**Application for Minor Amendments
to the Building B5 Reserved Matters
Approval 2014/6968/P**

King's Cross Central General Partner Ltd

September 2015

drawing no
EPA KXC 05 111

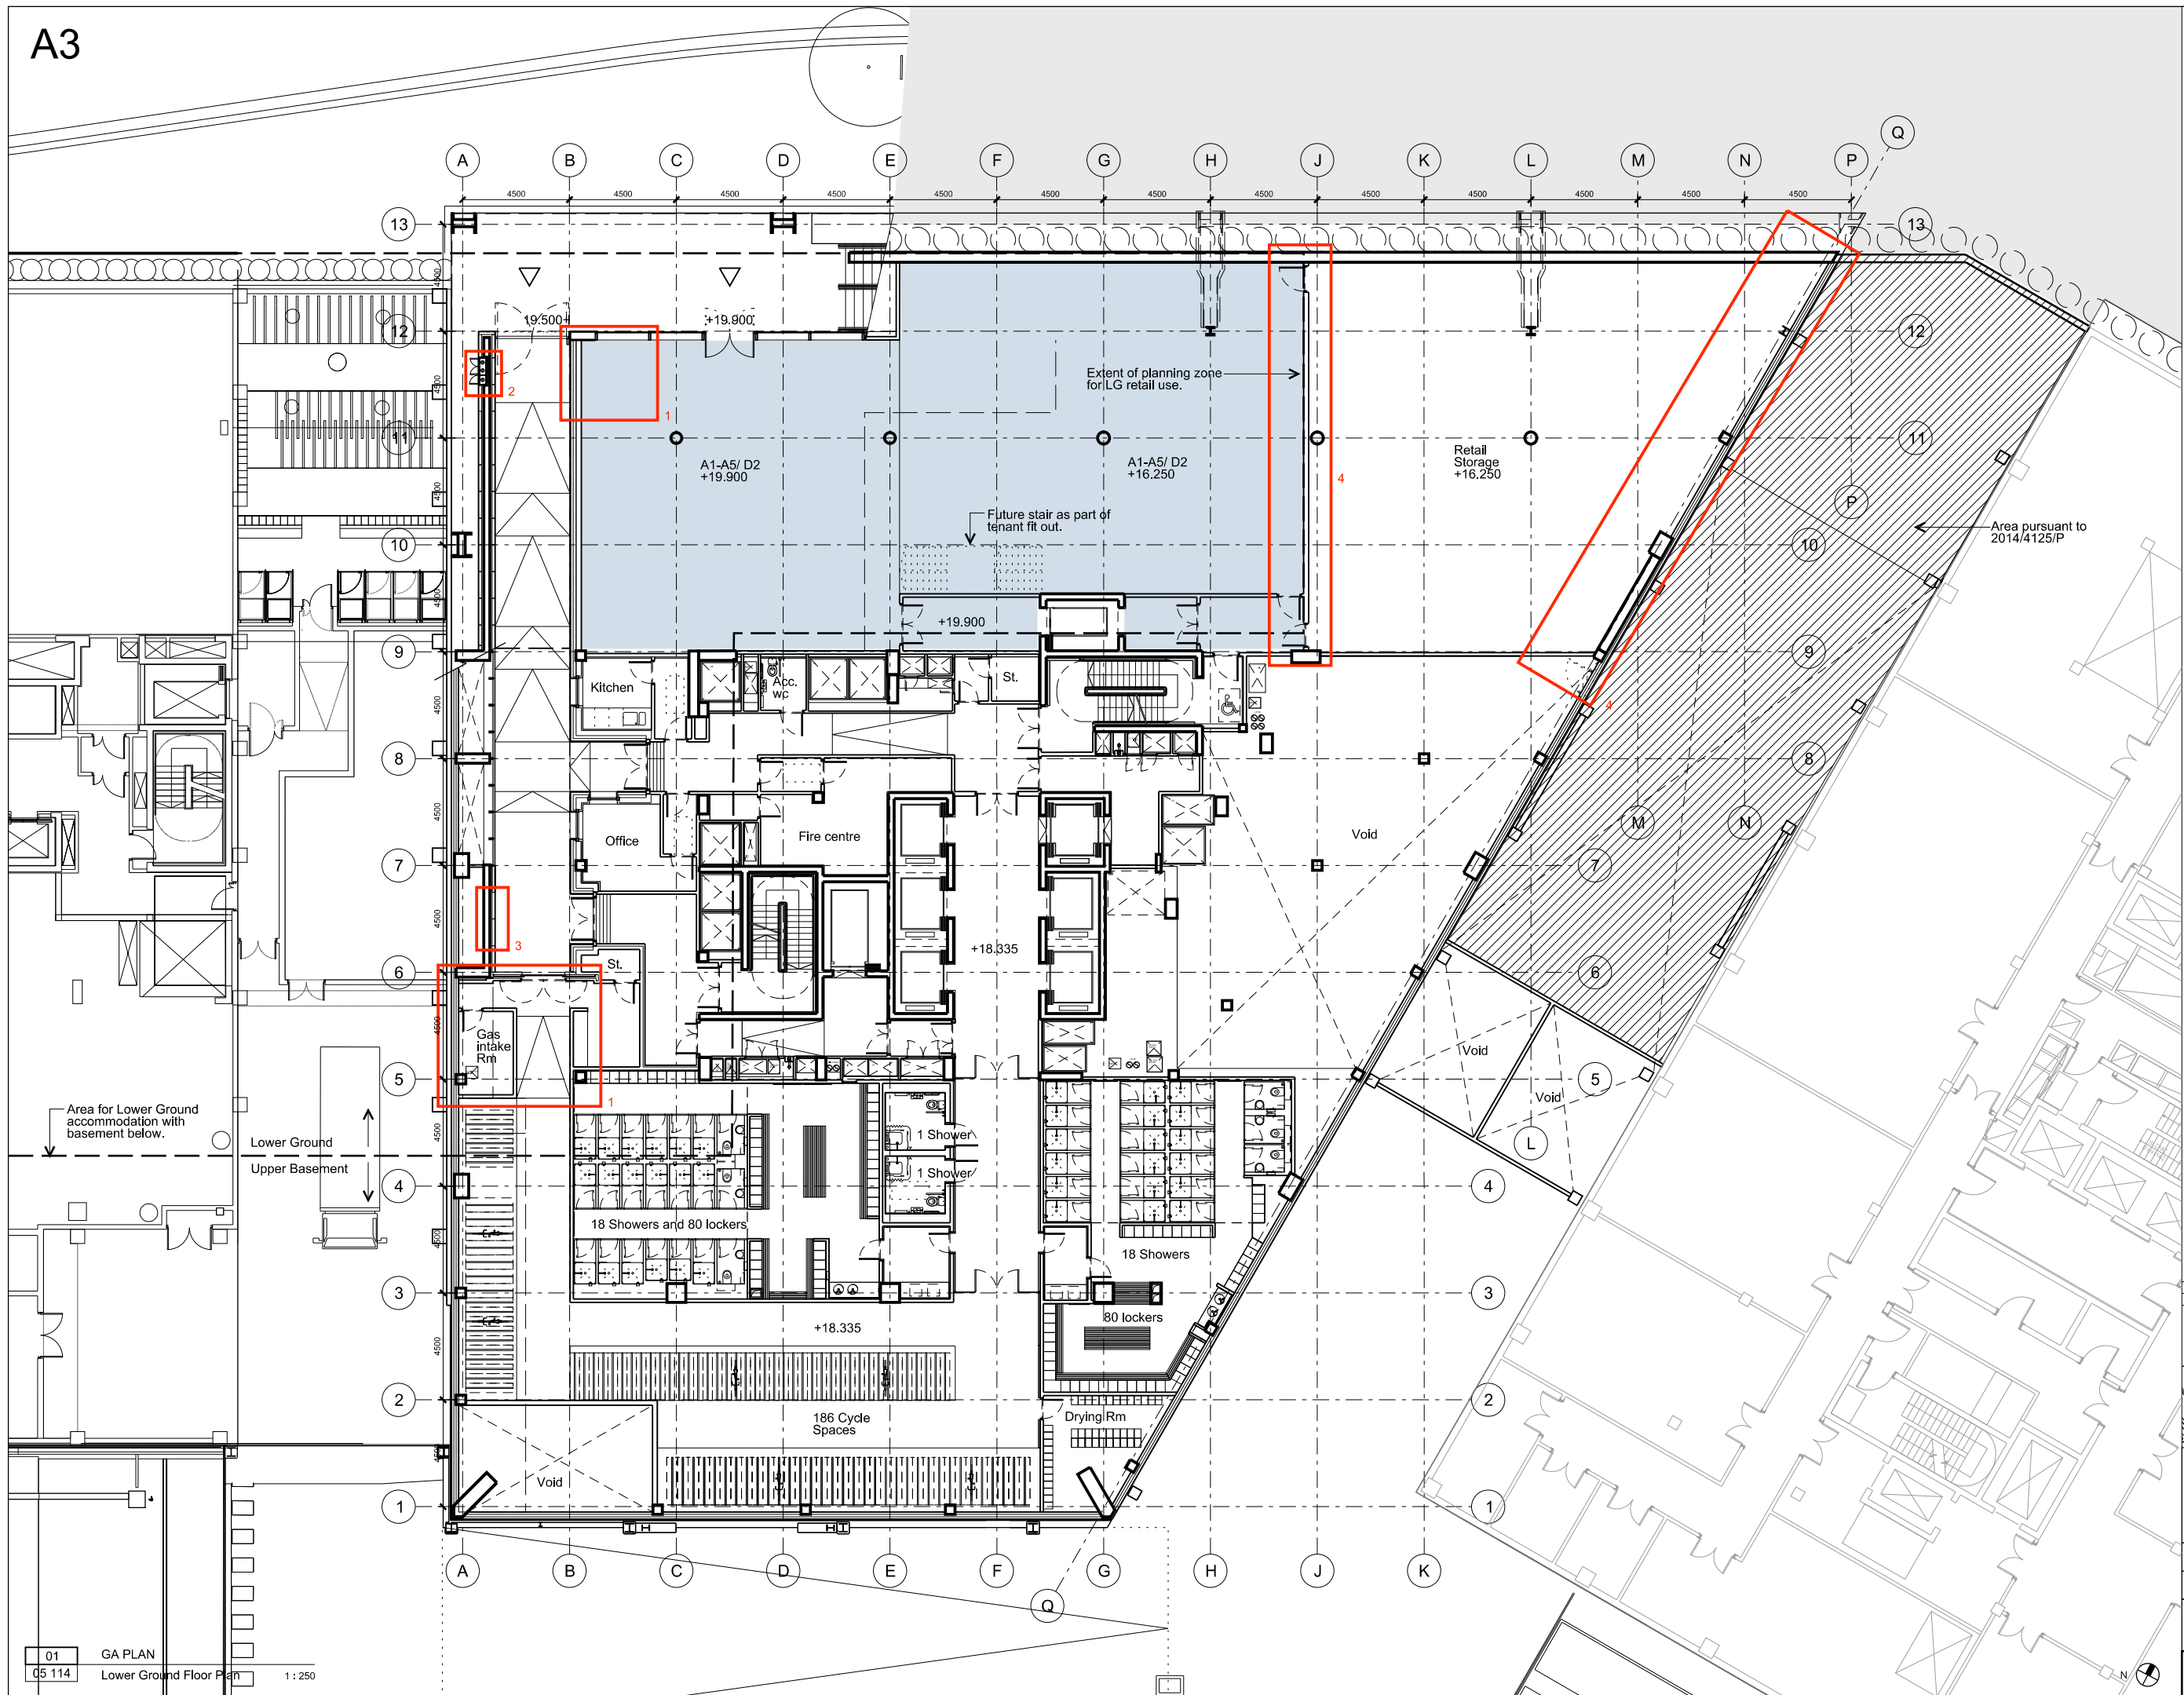
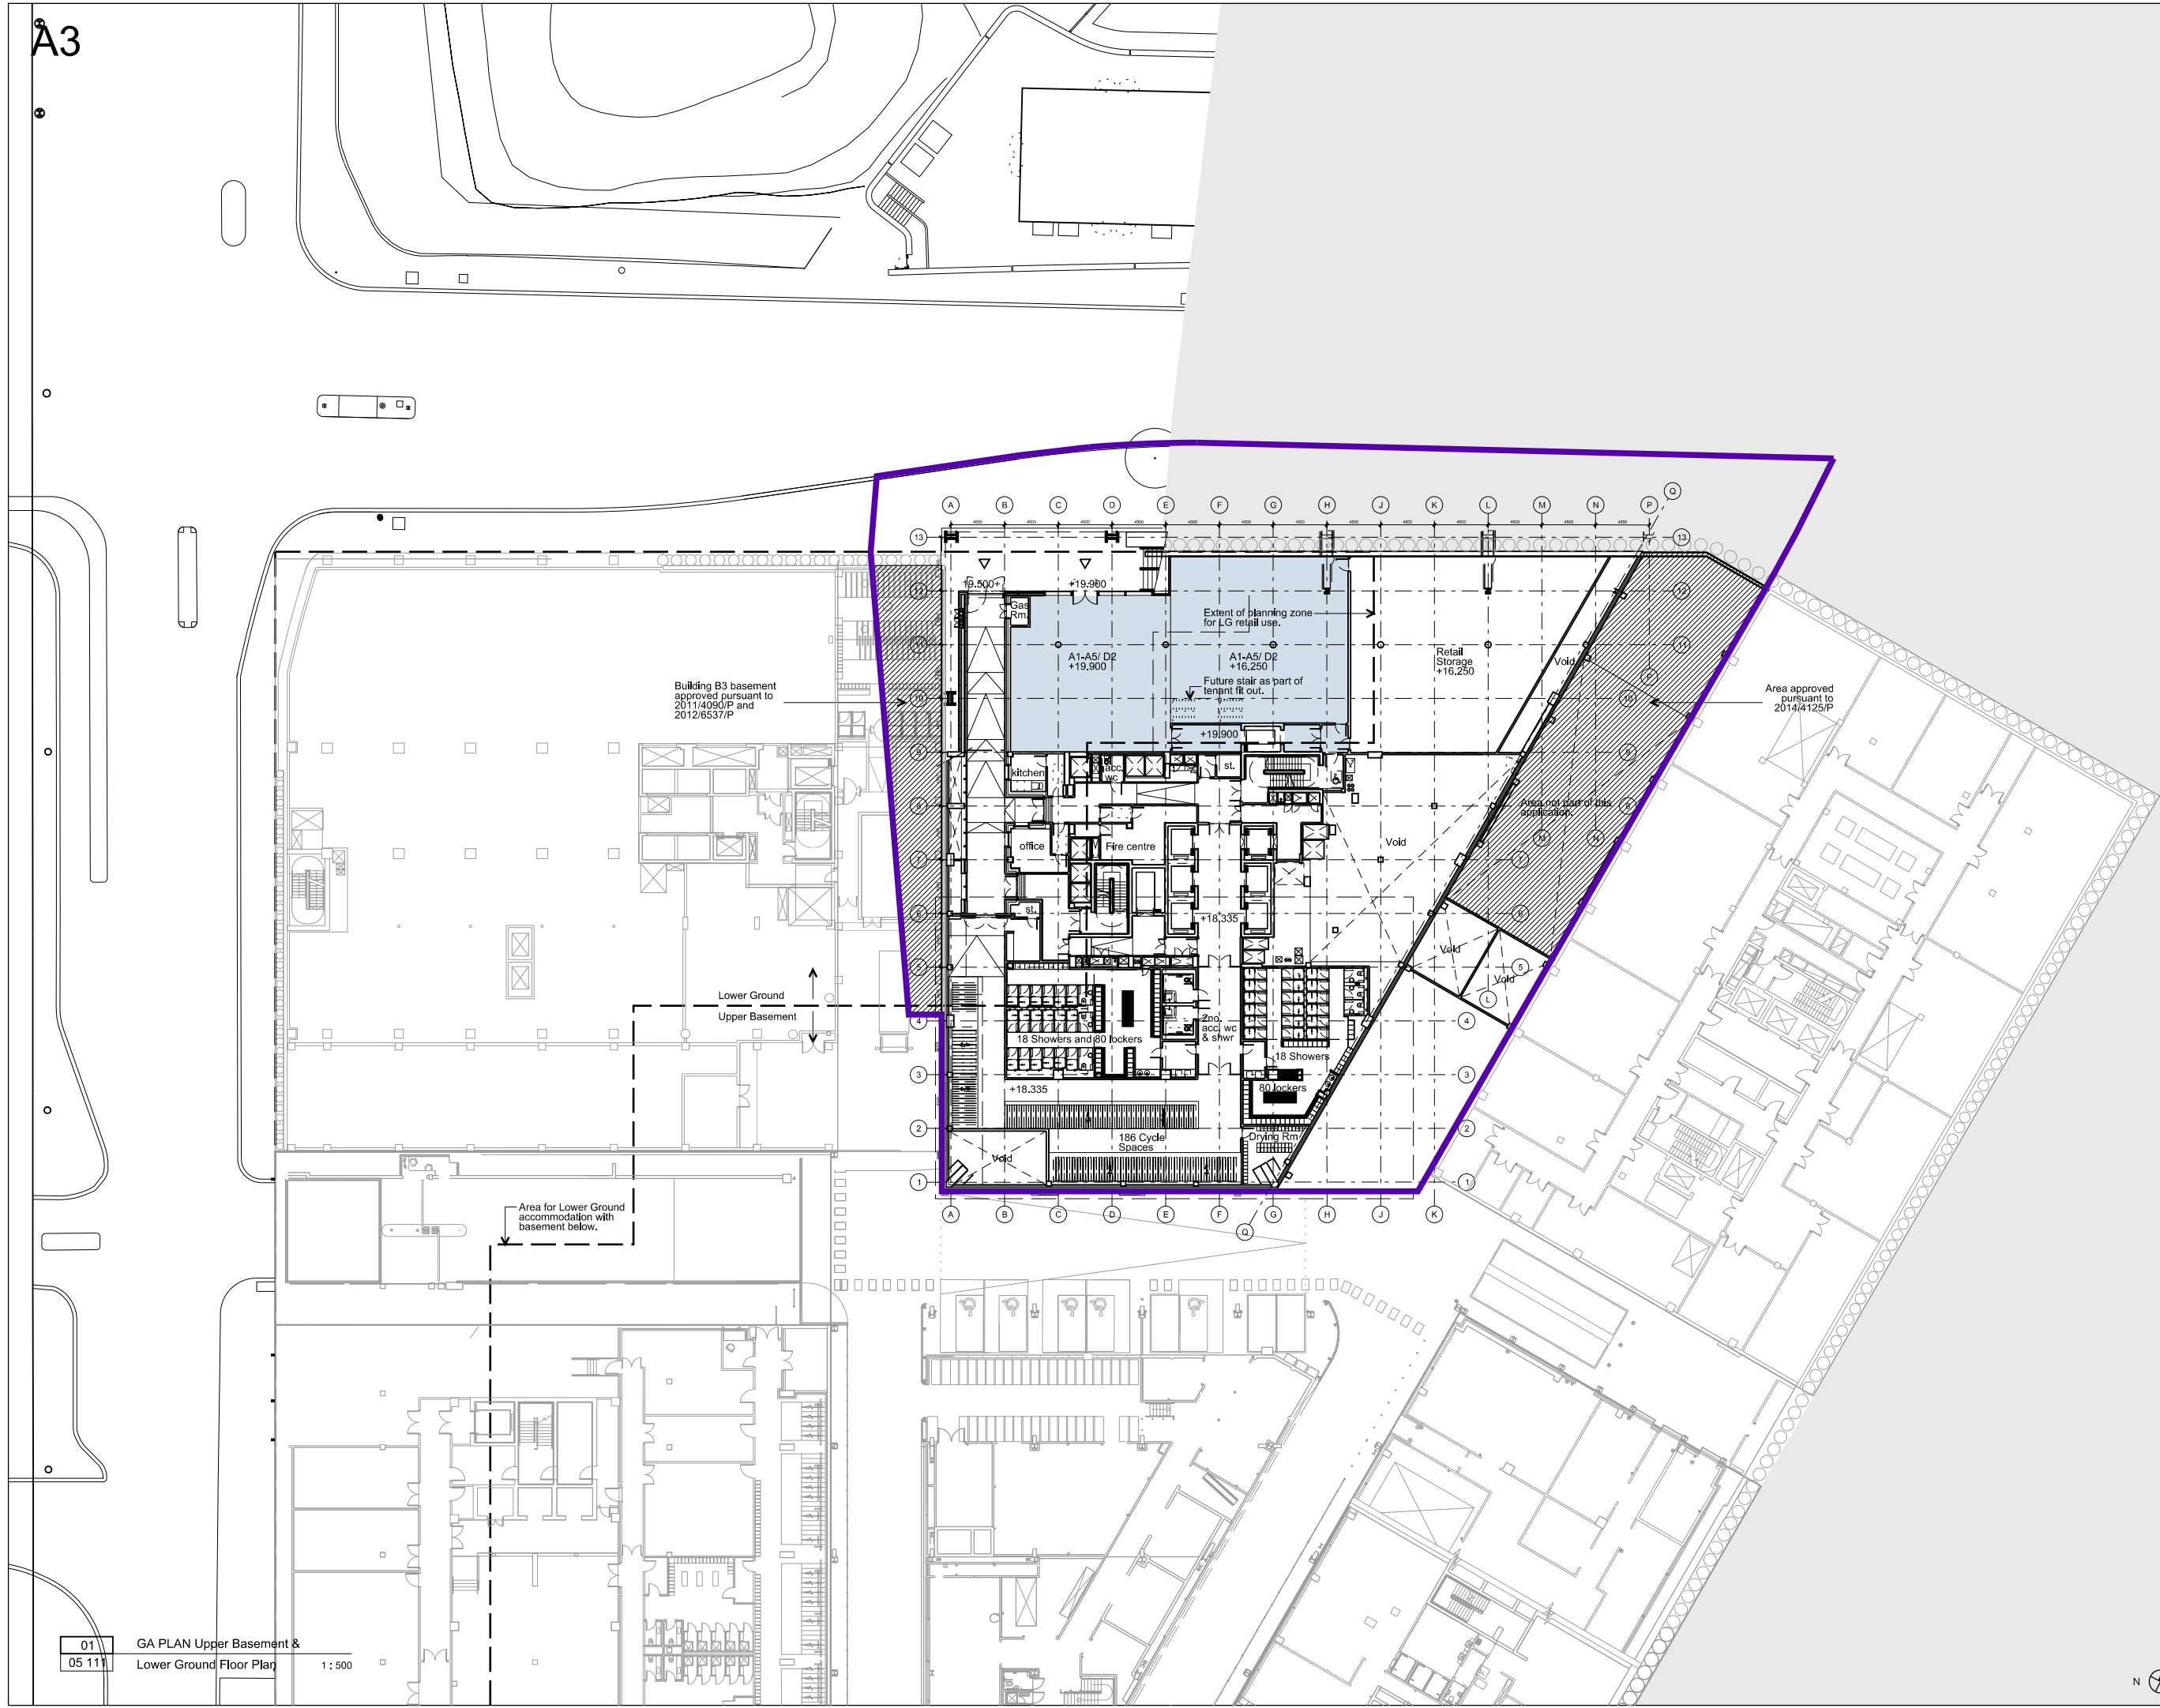
1. Gas Intake Room relocated to top of cycle ramp, louvred doors inserted to ramp side, and mullion and shadow box added to north facade, to conceal the Gas Room. Doors to Cycle Store centred on ramp, following relocation of Gas Room.
2. Fourth inlet cabinet added.
3. Louvres added to wall of cycle ramp to serve plant room below.
4. Retail area reduced following a shift in the wall between the lower ground retail floor and the upper basement retail storage areas; retail storage remains the same, by creating a void at its eastern extremity.

P4	Storage area reduced.	09.07.15	MM	RD
P3	Retail area reduced.	10.06.15	MM	RD
P2	Town access.	27.05.15	MM	RD
P1	Gas intake room relocated to top of cycle ramp. Foam inlet cabinet added. Louvers added to cycle ramp.	16.02.15	MM	RD
P0	Planning Submission.	29.09.14	JT	RD
Rev	Description	Date	By	Chk
